FORM APPROVED
OMB NO. 1004-0135
Expires: July 31, 2010**SUNDRY NOTICES AND REPORTS ON WELLS**
*Do not use this form for proposals to drill or to re-enter an abandoned well. Use form 3160-3 (APD) for such proposals.*5. Lease Serial No.
NMNM109756

8. Well Name and No.
PEACHES 19 FEDERAL 3H9. API Well No.
30-015-42446-00-X110. Field and Pool, or Exploratory
COTTONWOOD DRAW11. County or Parish, and State
EDDY COUNTY, NM**SUBMIT IN TRIPLICATE - Other instructions on reverse side.**

OXY USA Inc. respectfully requests approval for the following changes to the drilling plan:

WELL LOCATION AND ACREAGE DEDICATION PLAT

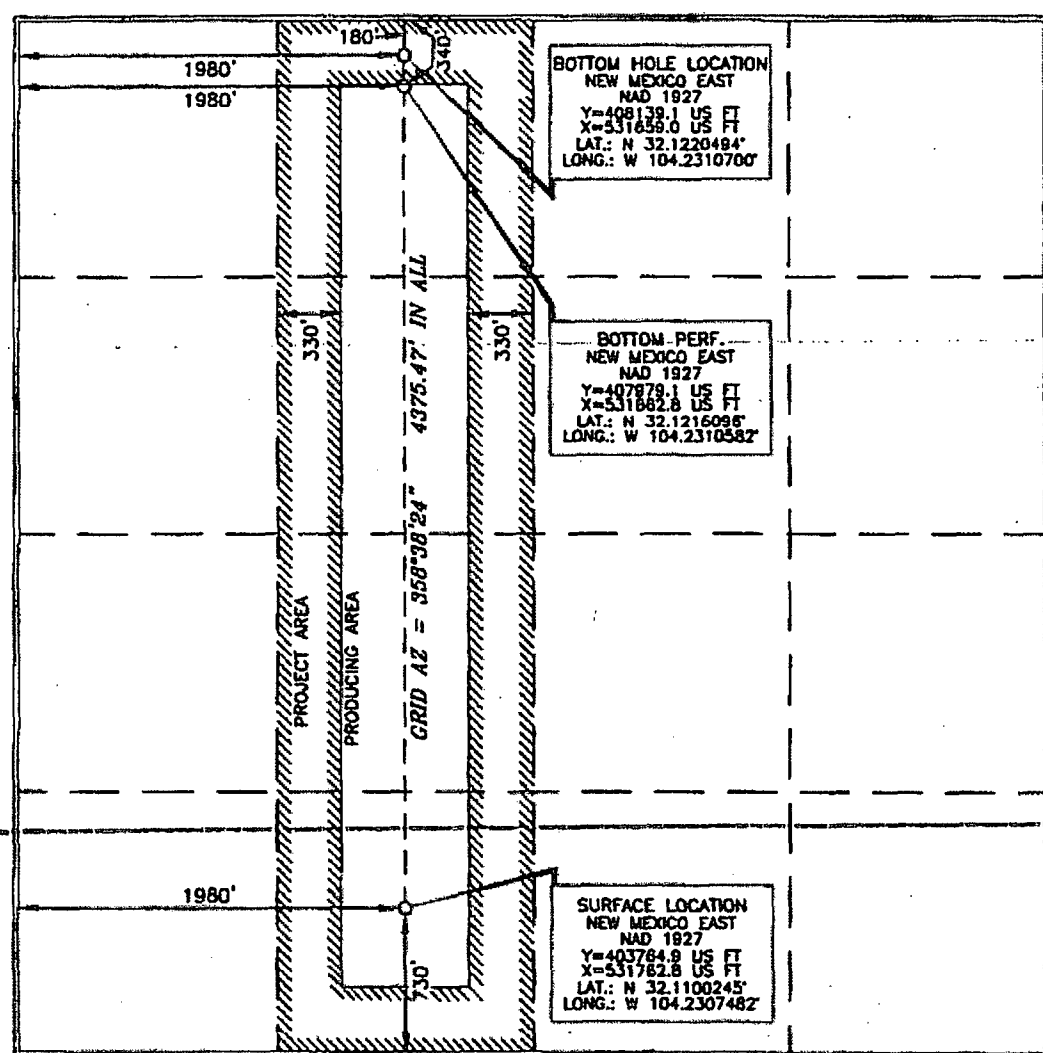
1. Extend the BHL approximately 150' past the north hardline to allow for our shoe track and perforating guns, see attached for amended C-102 plat and amended directional drilling plan.

UL or lot no.	Section	Township	Range	Lot Idn	Feet from the	North/South line	Feet from the	East/West line	County
C	19	25 SOUTH	27 EAST, N.M.P.M.		180'	NORTH	1980'	WEST	EDDY

Peaches 19 Fed 3H
Eddy County, NM (NAD 27 NME)
Northing: 403764.90
Easting: 531762.80
Design #2

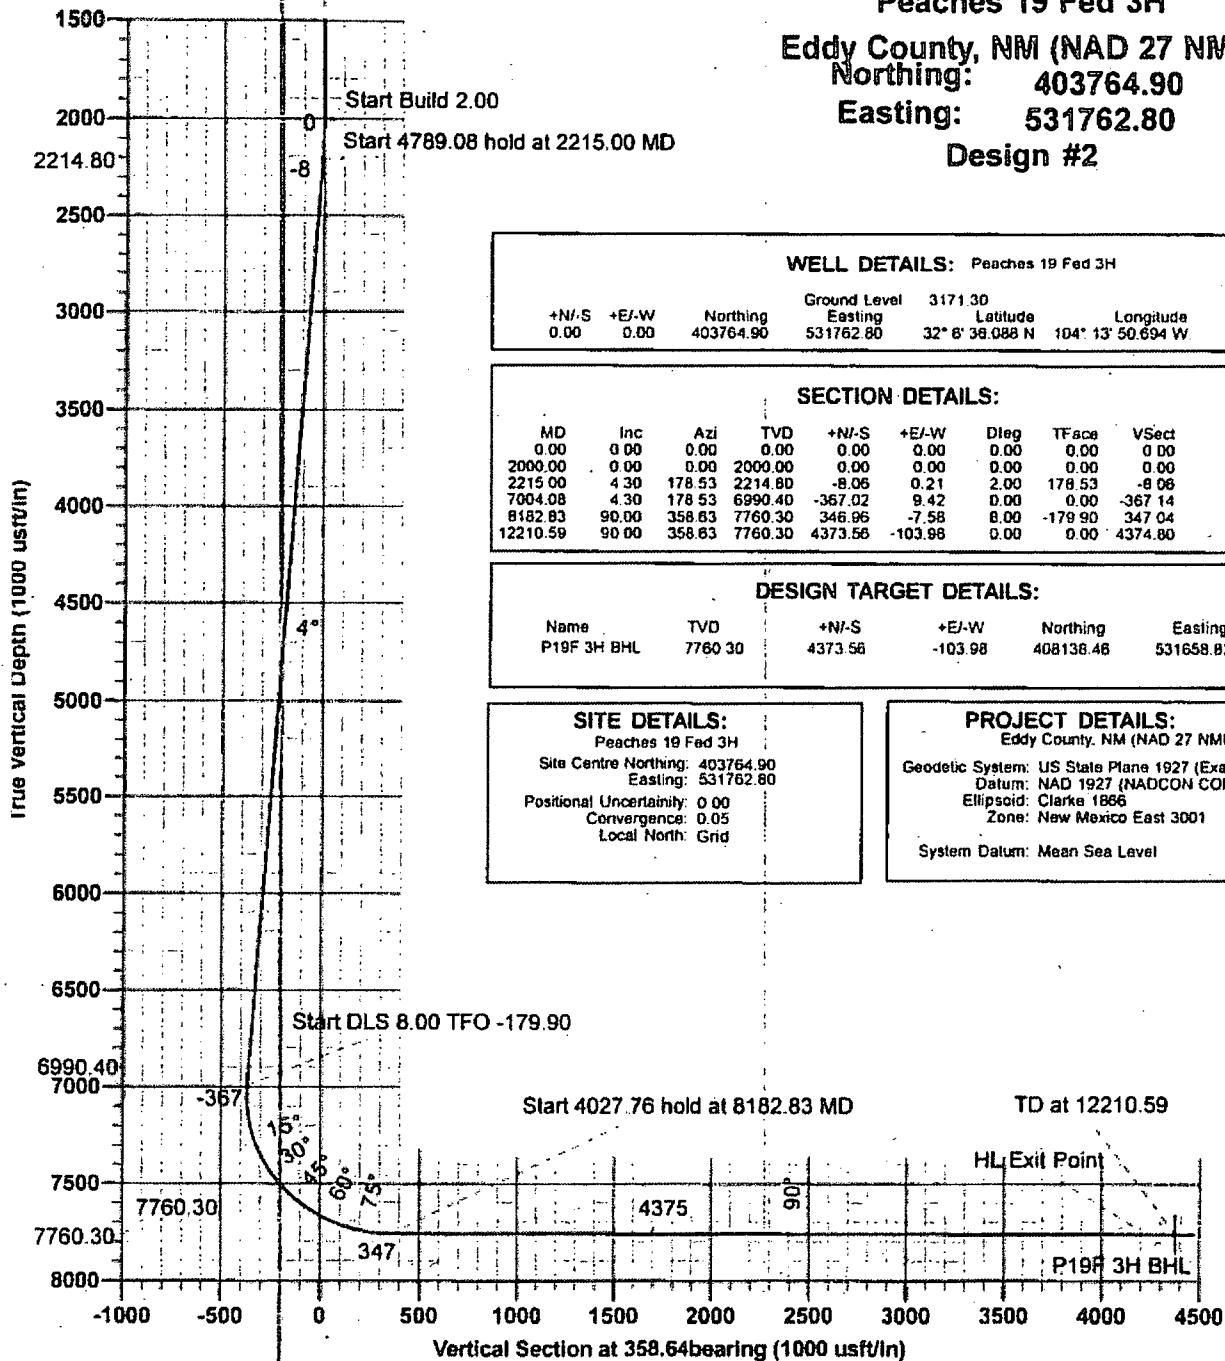
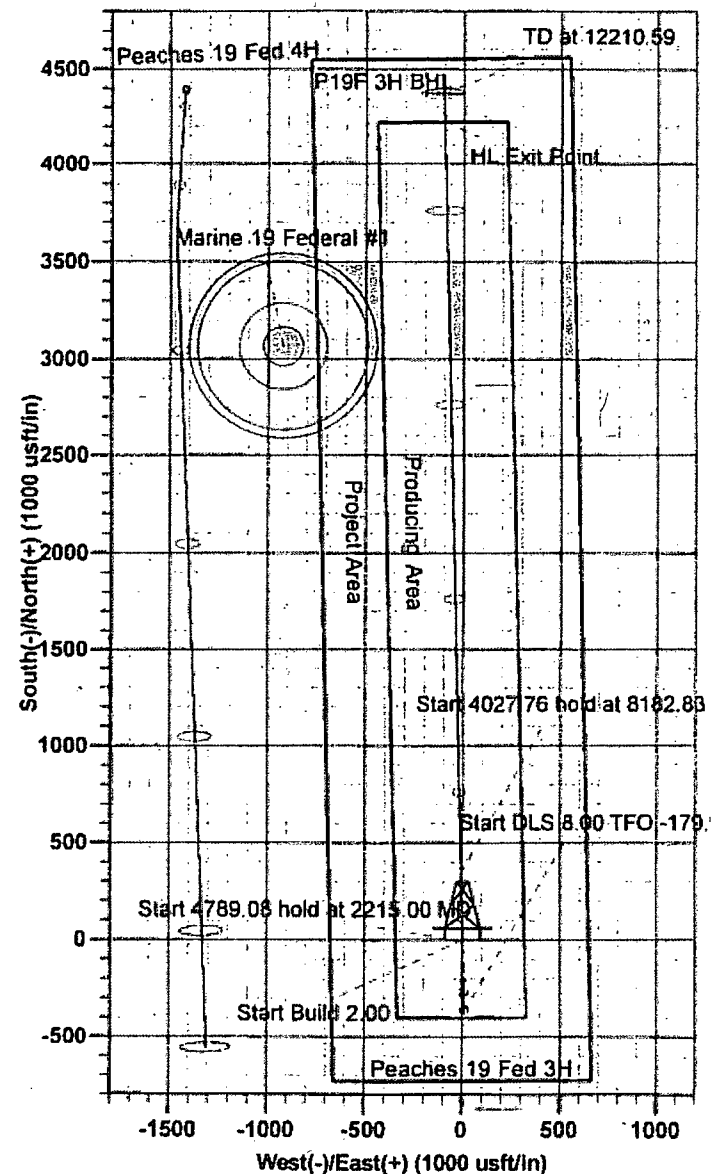
Proposed TD - 12211'M 7760'V
